Appendix 5: Changes to Strategic Sites

A5.1 Introduction

A5.3 Strategic Sites – Detailed Proformas and Maps

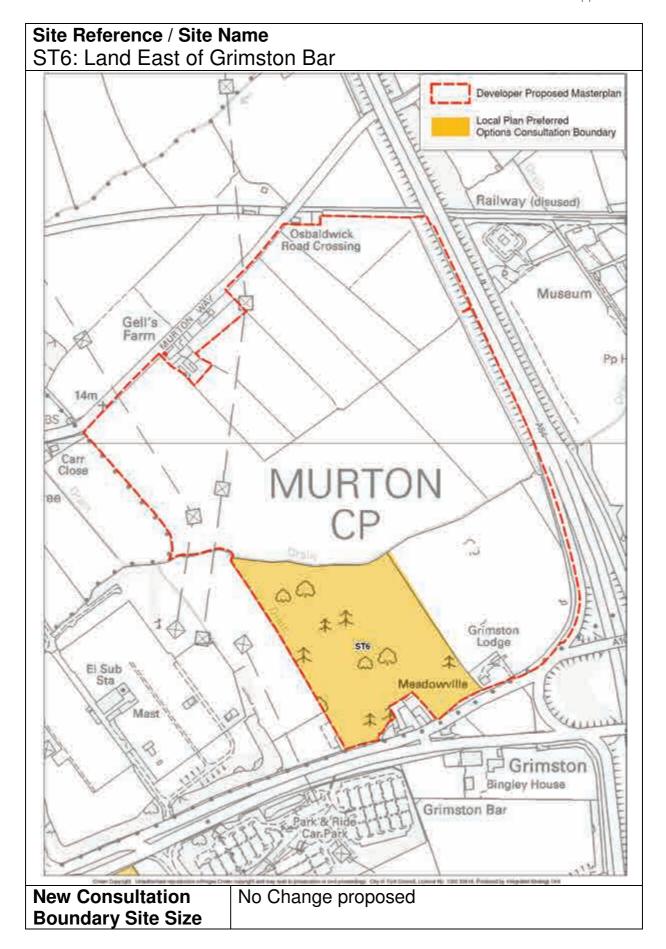
Inclusion of a small area of land to west of previous site boundary (ref. 733), and;

Exclusion of small area of land to south eastern preferred options site boundary.

New land to the west of the previous site was submitted for residential development through the last round of public consultation on the preferred options plan, and is potentially suitable as an extension to ST2 as part of a comprehensive development approach.

Land excluded at Westview Close has recently been granted planning approval for residential development, and has therefore been removed from the strategic site boundary

The importance of providing open space/ landscape buffering to sites boundaries, including retention of landscape features such as trees, was highlighted. Retaining perceptions of openness and preserving separation between York and Poppleton is a key issue here. Whilst not relevant to the proposed boundary changes, part of the site was formerly used as a sports ground, prior to relocation to a new facility nearby, and redevelopment proposals will need to respond to this issue.

Biodiversity offsetting and habitat creation off-site may be required.

Setting back development from Boroughbridge road is likely to be desirable/ essential in terms of managing noise and air quality impacts. The potential allocation extension should be accessed through the main ST2 development site only if taken forward.

| Decemmendation | To include the revised boundary to CTO to |
|-----------------|---|
| Recommendation: | To include the revised boundary to ST2 to |

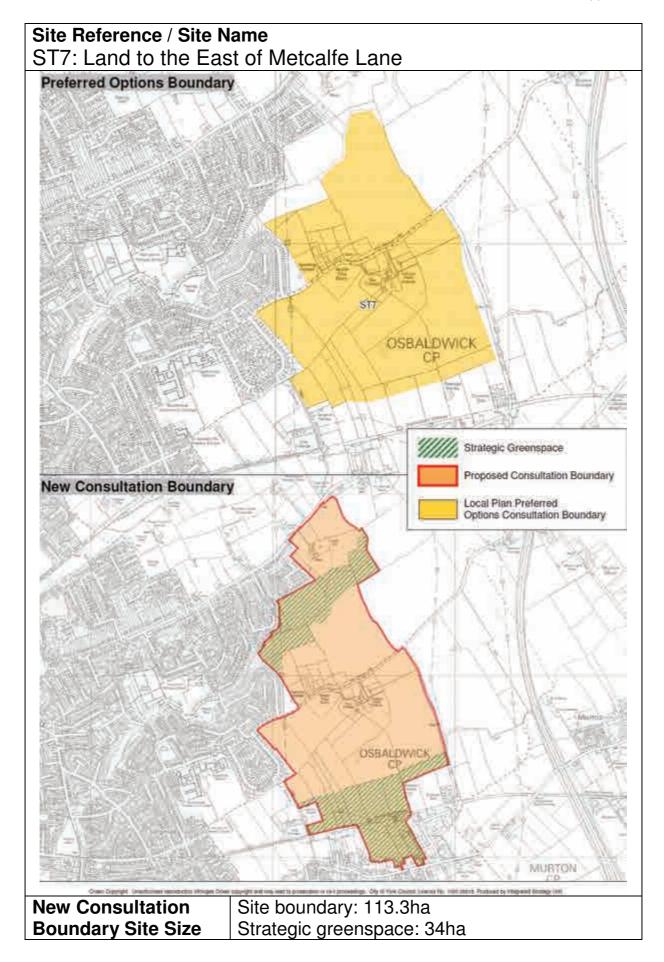
The site boundary submitted through the original 2012 Call for Sites was reduced to the boundary shown in the Preferred Options Local Plan (5.5ha) to reflect the existing constraints such as pylons, the proximity of the A64, landscape impact, setting of the city, preventing coalescence, and to protect 'ridge and furrow' historic agricultural uses.

Developers believe that delivery of a larger site (circa 29ha) is viable and deliverable whilst taking into account these constraints and will provide a more sustainable site with better linkages and a wider range of uses. They have put forward the area with pylons to the north west of the larger site for light industrial units and the areas containing ridge and furrow for multifunctional open space. They consider that the openspace in this area would perform the function of an area preventing coalescence. The site promoter has argued that the land to the east and north of the proposed allocation should be included within the site boundary as it does not fulfil any of the 5 purposes of Green Belt (NPPF) or the characteristics identified in the York Green Belt Appraisal (2003) criteria to any significant degree.

Officers consider that the landscape quality and character is of local significance, and it is felt that the presence of the pylons does not negate this. The wider area of land is perceived not only as contributing to the setting of Murton, but also as preventing coalescence between Murton and Dunnington and the city centre (part of the proposed extension to the allocation is in an 'area preventing coalescence' in the green belt appraisal). The landscape character should not be considered in isolation. This is a sensitive site location, particularly when experienced cumulatively and sequentially as part of the wider landscape along the A64 (and Hull Road) due to the rural hinterland location, and the rising topography up to Grimston, which increases its prominence. It is considered that conscious development in this location would remove sense of openness. The development of the A64 has opened up views of the city and shows the scale of the Minster

Development of the wider area would result in a loss of remaining linear field boundaries and remnant ridge and furrow associated with the medieval township of Murton.

Noise from the A64 and A1079 is a significant constraint to development and is likely to required mitigation measures to ensure satisfactory living conditions are provided from any proposed dwellings. There is the potential to build noise protection barriers but this is not an ideal solution due to potential impacts on the openness of the site.

The A1079 access options put forward in the transport assessment are unlikely to be acceptable given the impact of a signalised junction on the flow of traffic on the A1079 and Grimston Bar gyratory. Serious concerns exist around the extent of trips being made by foot, cycle or public transport, and sustainability of this location. Further detailed analysis would be needed to evidence the proposal.

| Recommendation: | No proposed change to Local Plan Preferred |

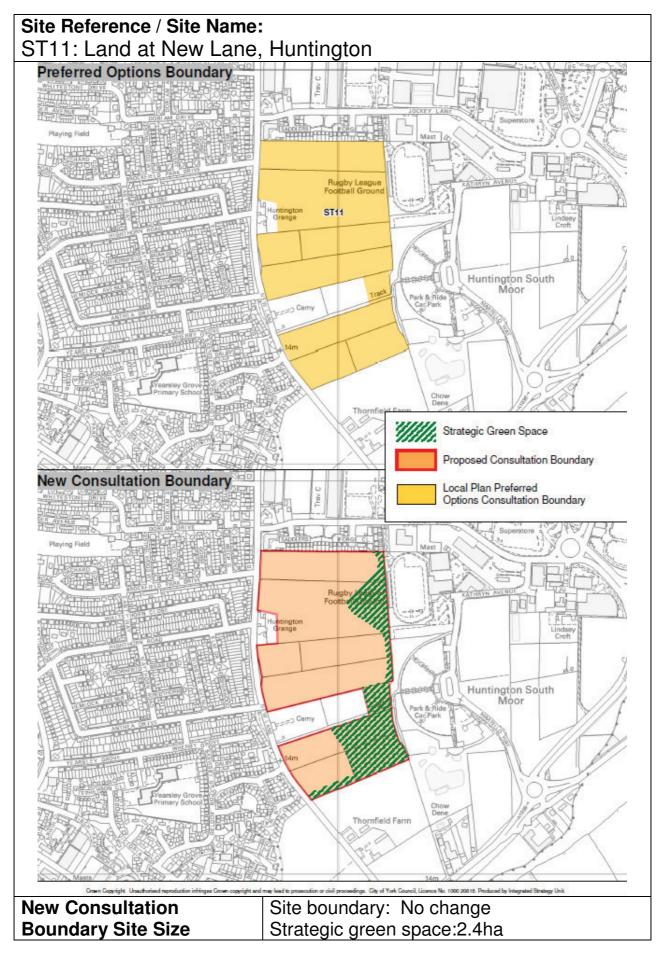
A larger site allocation was proposed by site promoters, extending the site area to the west, south and east of the original Preferred Options site, but including strategic green space provision. A separate 12ha parcel of land to the northwest of the allocation was also put forward by the sites promoters.

Site promoters contended that a more strategic housing opportunity exists in the wider site boundary, without causing material harm to the greenbelt, given the land's self containment and strong physical features to its boundaries. They state that a long-term defensible greenbelt boundary can be created in the wider site, whilst delivering more housing to meet city needs.

The proposed revised site boundary also included a linear greenway to the southern edge of the site, to provide amenity space, accommodate flood storage, and define a landscaped edge with impermeable barrier to manage the relationship with the adjacent SSSI. A buffer of around 150m width was proposed by the site promoters to manage the complex relationship between the resultant development site and the SSSI.

The informal views of Natural England and the Yorkshire Wildlife Trust are that a 150m buffer will be inadequate to satisfactorily manage the relationship between the development site and SSSI.

The proposed boundary extensions would also have landscape and heritage impact issues, and are on land identified within the Cities greenbelt appraisal evidence base as being an important character area retaining the rural setting of the City. The proposed extensions to the west of the original boundary would have a particularly severe heritage impact, as a result of their proximity to the Outer Ring Road and impact on the setting of the city and key views of the minster and city – bringing development into the foreground of these views.

The wider proposed development area surrounding the Preferred Options allocation would have landscape and greenbelt impacts and whilst the principle of providing a green wedge between the site and Askham bog in order to mitigate impacts is supported, the extent of this strategic green space buffer and development area would require very careful consideration, and robust evidencing as part of the masterplanning process. Strategic green space will have an important function in terms of setting of the City as well as the landscape setting of Askham Bog - the countryside setting of this important landscape asset for existing and new residents. Land to the south of the preferred options allocation is identified as greenbelt character area 'retaining rural setting', and was proposed to form part of the greenbelt in the Preferred Options draft plan given it's landscape quality and the sensitive nature of this area in terms of establishing the setting of the city. Development along Moor Lane would reduce views across the rural landscape, including Askham Bogg. From this perspective alone, although the depth of development is less critical than at the western site boundary, it would still compromise the landscape setting of the city.

The principle of providing a green buffer will broadly help to reduce ecological impacts on the adjacent Askham Bog SSSI (through hydrological changes or disturbance impact). A buffer of around 150m is currently proposed but this is felt by stakeholders to be inadequate given the sensitivity of the SSSI site and the complex relationship it will have with the development. Irrespective of the scale of buffer, there is also likely to remain an ecological impact on the site that will need to be assessed and control/ mitigation measures proposed in detailed masterplanning.

The masterplan approach should reduce 'disturbance' impacts by not allowing direct access to the SSSI, and creating a barrier to the movement of people and domestic pets. Use of any green buffer for recreational purposes will reduce its effectiveness in terms of

The hydrological relationship between the development site and SSSI is of critical importance and is subject of ongoing technical assessment. Flood and surface water storage measures that may be required to manage the hydrological relationship with Askham Bog should not be classed as open space in terms of meeting site needs, and may therefore also increase the extent of green buffer if included within it. Similarly areas of the green buffer that are not publically accessible (in order to reduce disturbance impacts) may have little function in terms of meeting open space requirements generated by the site.

Archaeological assessment of the site is required in order to establish the extent of constraint this will present – the location and extent of archaeological remains within the site is currently unknown, though ground conditions would indicate that remains may be well preserved. Archaeological interest may preclude provision of flood storage and attenuation measures in parts of the site, and dependent on their scale and location, could significantly impinge on the developable site area.

Recommendation: No change to original Strategic Site boundary

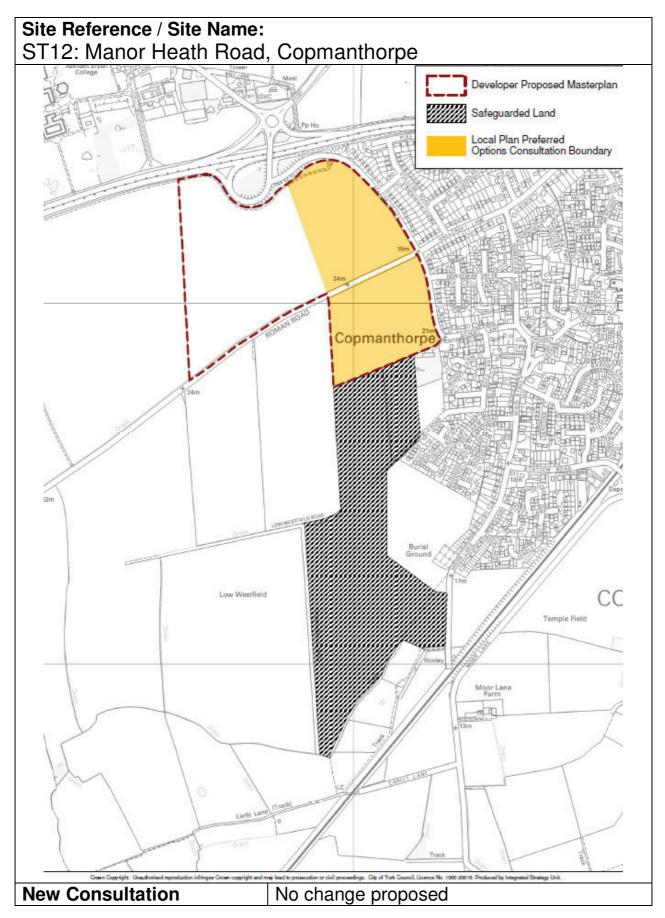
Although the site boundary has not changed, strategic green space has been identified within the allocation site, including the area around a Scheduled Ancient Monument.

The strategic green space has been identified to allow retention of and appropriate setting for heritage assets within the site, as well as providing a green corridor to the site boundaries for ecological and landscape purposes.

The site contains 1 Scheduled Ancient Monument (SAM). An evaluation of how the development and loss of space affects their setting will be required. Particular concerns were raised over adequate buffers to the SAM within the site. Currently, the SAM is in an open field setting. Development will constrain this setting.

The proposed allocation also contains a Site of Local Interest for nature conservation (SLI) to its south east corner, which has now been included in calculating site area. This designation is primarily for semi improved neutral grassland, though the site is also within 100m of a known great crested newt site. Although not identified in plans as strategic openspace, the approach to development around this area will need careful consideration and ecological retention, mitigation, management and enhancements may be required, both for the wildlife interest and in order to maintain a natural green space around Monks Cross with connectivity to the open space and countryside in the wider area.

| Recommendation: | To include within the boundary of ST11 |

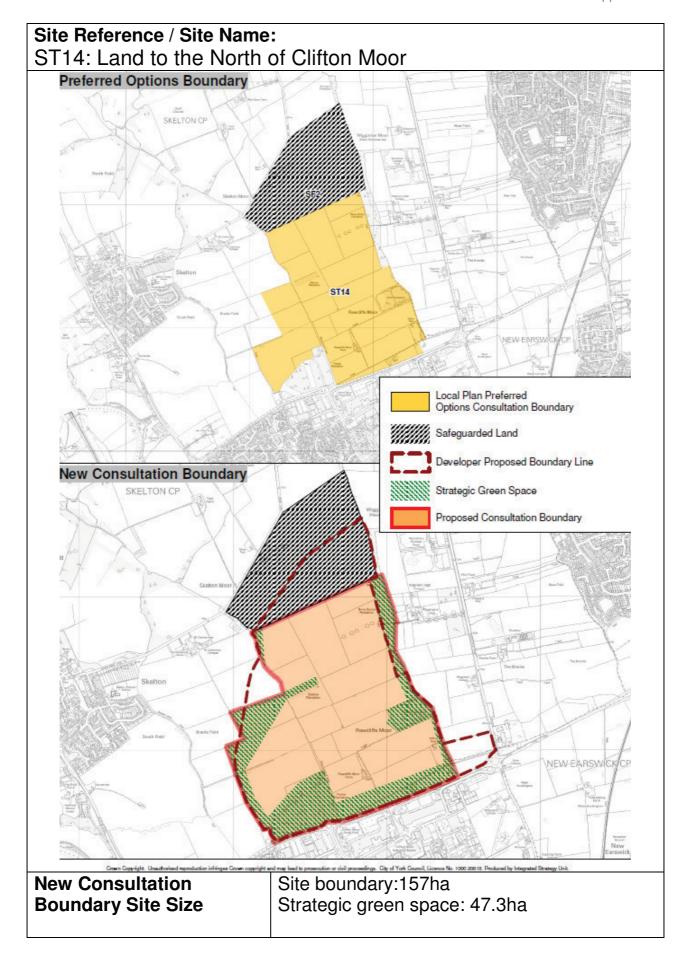
The site promoter has proposed a larger boundary of 29 hectares for these reasons:

- Land to the west of allocation and forming the larger site is said to be free of technical constraint but owned by Askham Bryan college, who have no use for it;
- would result in a more sustainable and inclusive development; to contribute to meeting the city's housing needs;
- to respond to site context, landform and vegetation and to provide a softer edge to Copmanthorpe whilst not attempting to "hide" the village;
- to generate higher commuted payments towards off-site sports pitches and, potentially, off-site highway improvements;
- to assist in promoting non-car travel by improvements to public transport services and robust Travel Plan initiatives;
- to provide meaningful areas of on-site open space and landscaping, together with generous provision for SUDS which will also provide an ecological resource.

The proposed extension to the site would not create a logical rounding off of the settlement that would be achieved through development of the site proposed in the Preferred Options. Housing within the western extension would be located at a distance that is considered too far from Copmanthorpe village centre and the masterplan provided does not include any facilities, other than open space, within the site.

The preferred options allocation covers large fields typical of west Copmanthorpe, punctuated by trees and hedgerows. Use of open space to form the western boundary of the site would need careful treatment to preserve impressions of openness that are characteristic of the area, use of floodlighting or MUGA etc would be more intrusive than say allotments.

Development would need to soften the currently very hard interface between the village of Copmanthorpe and the greenbelt. Need to protect trees and hedgerows within the development and preserve character of Copmanthorpe.

As the site is close to the A64 and slip roads, careful consideration will need to be given to the site design to ensure any residential uses are set back from the carriageway in order to manage noise and air quality impacts.

| Recommendation: | No change proposed to the original Strategic |
